From: [Garza, Johnnie](#)
To: [Pat Womack](#); [Misti Schulz](#)
Cc: [Lissak, Matt](#); [Adam Boatright](#); [Kamie Fitzgerald](#)
Subject: RE: Taylor - Williamson County Transportation Plan
Date: Wednesday, July 29, 2026 1:58:10 PM
Attachments: [image002.png](#)
[image003.png](#)
[image004.png](#)

Subject: RE: Taylor - Williamson County Transportation Plan

Thank you for taking my phone call. Attached is a markup showing the property we're developing in Taylor, TX, overlaid on the Williamson County LRTP Amended Mapbook.

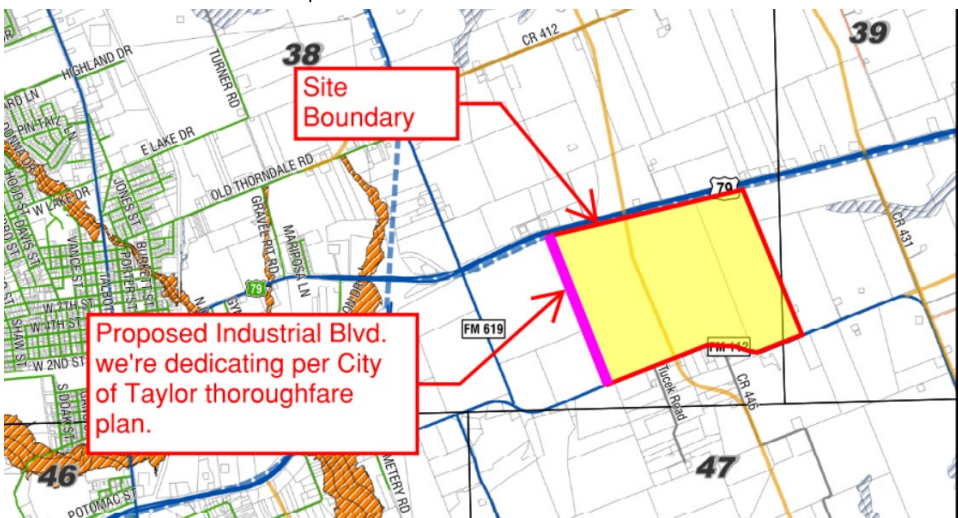
1. Is the LRTP Amended Mapbook the current transportation planning document for Williamson County? I assume it is since it is an amendment, but I wanted to confirm. The City of Taylor GIS map does not appear to align with the amended mapbook, and I want to make sure we're coordinating with the correct planning documents before submitting to the City this Friday.
2. Is there any flexibility within the LRTP regarding roadway alignments? Since we're already proposing and dedicating a roadway along the west side of the property (pink line shown on the exhibit), we're hoping to understand whether there is any opportunity to align both thoroughfare plans.
